MEMORANDUM

TO: Historic Preservation Board
FROM: Trisha Logan, Planner III, City of Fort Lauderdale
SUBJECT: 927 SW 2nd Court
DATE: April 3, 2017

Case	H17002	FMSF#	
Owner	N.J. Thompson, Inc.		
Applicant	Nancy Cortez		
Address	927 SW 2 nd Court		
General Location	Approximately 70 feet east of the SW 2 Court and SW 10 Avenue intersection (north side).		
Legal Description	WAVERLY PLACE 2-19 D LOT 13, 14 & E 5 OF LOT 15 & 5 ½ VAC ALLEY		
Existing Use	Single-Family Residential		
Proposed Use	Multi-Family Residential		
Zoning	RML-25		
Applicable ULDR Sections	47-24.11.C.3.c.i, 47-24.11.C.4.c, 47-17.7.B, 47-24.11.C.3.c.iii		
Request(s)	1. Certificate of Appropriateness for Demolition - Demolition of an existing single-family residence. 2. Certificate of Appropriateness for New Construction > 2000 SF GFA - New Construction of a new two-story duplex.

Front Elevation of Existing House

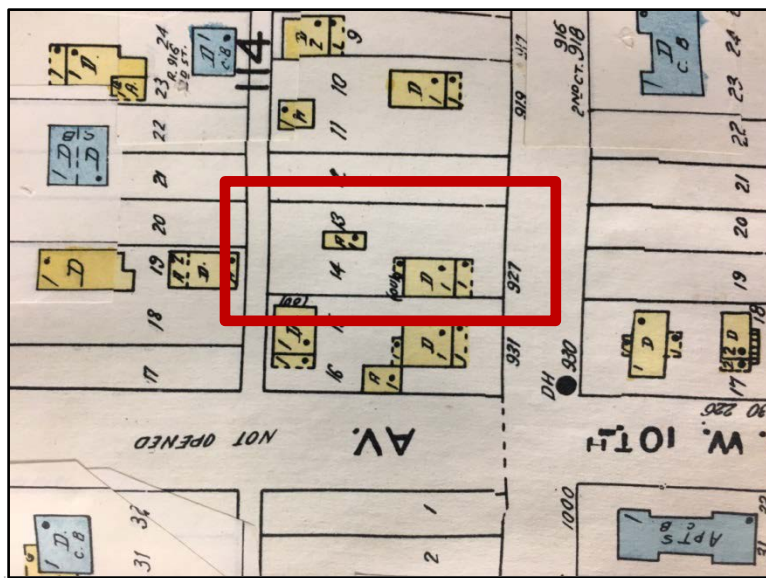
Additionally, the narrative also states that, *"Because of the significant wood rot and decay of its primary structural components, the applicant has decided that the rehabilitation of the property is no longer feasible."* The applicant did not provide substantive evidence of the current condition of the structure by either providing detailed photographs and/or an existing conditions report that outlines the decay as stated in the narrative to substantiate an unusual or compelling circumstance to warrant demolition in this particular case.

The applicant is asking for the demolition of an historic house, a contributing property in the SBHD and demolition should not be considered the only option. It is not evident that the property owner has made a reasonable effort to explore options that include stabilization and rehabilitation. The application should be **denied**, however if the HPB determines a compelling case for demolition may be considered, staff would urge the HPB to request additional information on the condition of the structure or the potential to rehabilitate, prior to making a final determination and to defer this request to the May HPB Agenda.

Front Elevation of Proposed New Construction Project

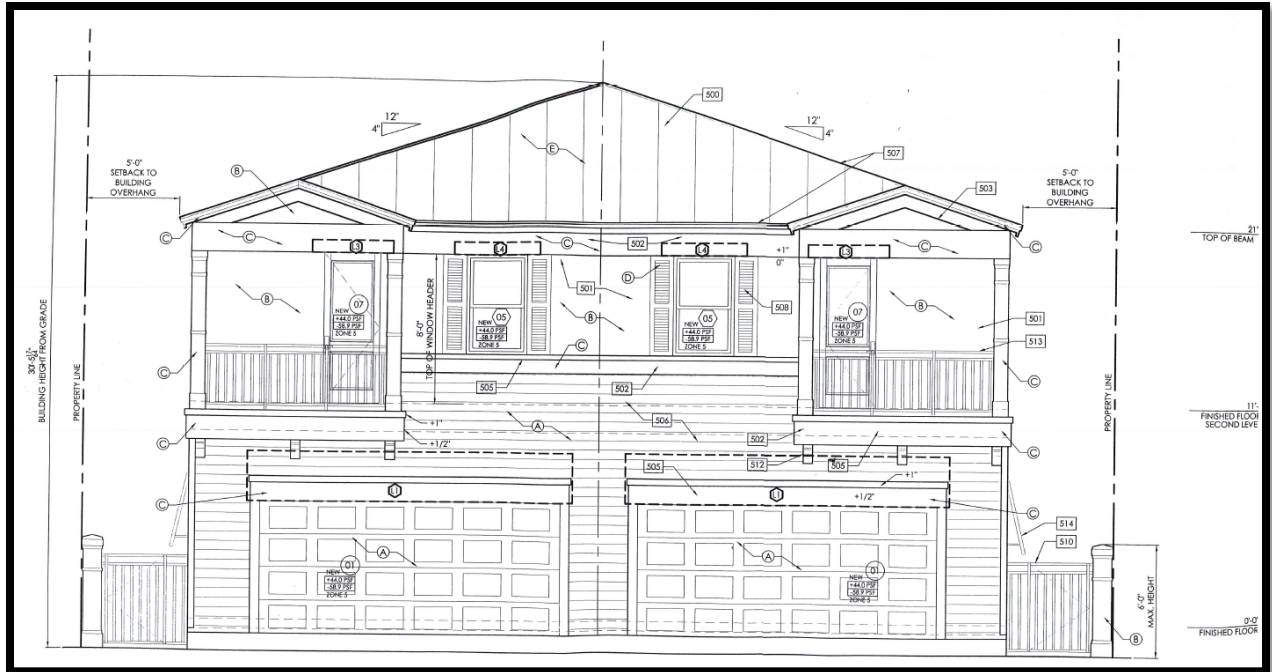
The applicant is requesting a Certificate of Appropriateness for new construction of a new two-story duplex. Overall the new structure is a rectangular floor plan, rising to two stories, with a metal gable roof. Materials on the exterior include wood, metal, and stucco. The front façade of the proposed new construction project contains two two-car garages on the first level, creating two 16'-0" wide driveways with an approximately 4'-0" wide grass median between. On either side of the structure there are metal picket entry gates, tied into a 6'-0" high masonry piers, each gate leads to a recessed front entrance located on the side elevation of the building. Above on the second floor there are two projecting balconies on each corner with two single-hung windows that are symmetrically placed from the center line of the structure, and are framed with inoperable wood shutters.

Within the Sailboat Bend Historic District, it is evident that most historic residences did not have garages that were incorporated in the primary façade of a structure. Majority of the houses had a separate structure that was set to the rear of the lot that would serve as automobile storage. When designing new construction to fit in with the context of the surrounding district, this is an important element to consider since the addition of wide driveways and imposing garage doors will interrupt the rhythm that currently exists along the street. The proposed width of each garage door also exceeds the allowable width per the new construction historic preservation guidelines.

Additionally, locations of fenestration and overall massing do not fit in with the context of the neighborhood. Regarding the fenestration, the entrance of historic residential structures are typically found on the front facade rather than on the side. One of the main rules in designing for a new construction project in a historic district is to imitate the façade proportions and rhythm in placement fenestration throughout the façade. On the proposed new design, there are a variety of window sizes and types placed on the exterior of the structure with ten different size variations present, creating visual clutter on the exterior elevations. Overall massing is one continuous rectangular box without much division in height or width to aid in breaking up the building mass that will be imposed on the neighboring one-story structures.

Height of the proposed new construction project rises to 30'-6" to the top of the roof ridge and allows for a 25'-0" setback in the front, 5'-0" side setbacks, and a 10'-0" rear setback. The front setback should be aligned with the neighboring structures. It appears that the neighboring structures are at approximately 20'-0" each, while the proposed project is at 25'-0". The UDLR requires a minimum front setback of 25'-0", however when a structure is located in the Sailboat Bend Historic District – the front setback may be reduced to up to 15'-0" in order to allow for compatibility with the abutting properties. In this case, the applicant must verify the setback of the neighboring structures and align the new construction project accordingly.

Multiple design influences are present including Bahamian, Colonial Revival, and Frame Vernacular. It is unclear how the blend of these historic styles that are found throughout the neighborhood complement the context in which it would be placed.

1. The overall width of each garage door is 16'-0" which exceeds the 9'-0" maximum width.
2. Although the applicant is providing operable Bahamian wood shutters in some locations, there are inoperable wood shutters on second floor of the front façade where the size does not match the size of the opening.
3. Sizes and placement of doors and windows throughout the house is inconsistent with others on the street and throughout the historic district.

1. Break-up the overall massing of the rectangular structure and provide a spatial difference between the new construction project and the neighboring structures;
2. Alter locations and sizes of windows and doors to provide consistency within the context of the street and overall historic district;
3. Adjust front setback to align with neighboring structures;
4. Reduce the size of garage doors and impact of the location on front façade; and,
5. Ensure design compatibility within the Sailboat Bend Historic District and provide justification of material and detail choices.
